Urgent Field Safety Notice

Commercial name of the affected product: Accelerator a3600

FSCA-identifier: FSCA – ACP – 202303 – 02

Date: March 10th, 2023

Image 1: Divert gate position

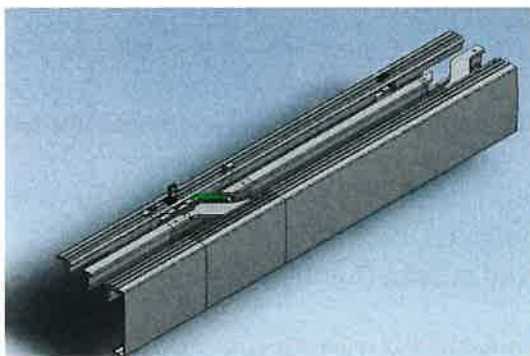
To avoid the occurrence of the described issue Inpeco recommends to visually check every day the gates at the buffer lane entry of the impacted modules (refer to Image 1) to verify that:

If the visual check is not passed, contact your local technical support for assistance before using the Automation System impacted modules to process samples.

Image 2: Divert appearance

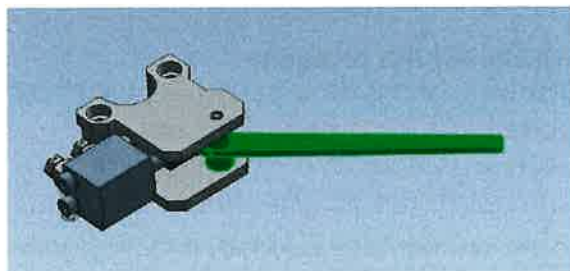
- there are no obstructions that prevent the correct activation and movement of the divert;
- the divert looks to be intact, refer to Image 2;
- the position of the divert is aligned to the profiles when it is diverting a tube, refer to Image 3; tubes that need to be routed by the module are diverted fluidly, without any missing or partial block of the carrier.
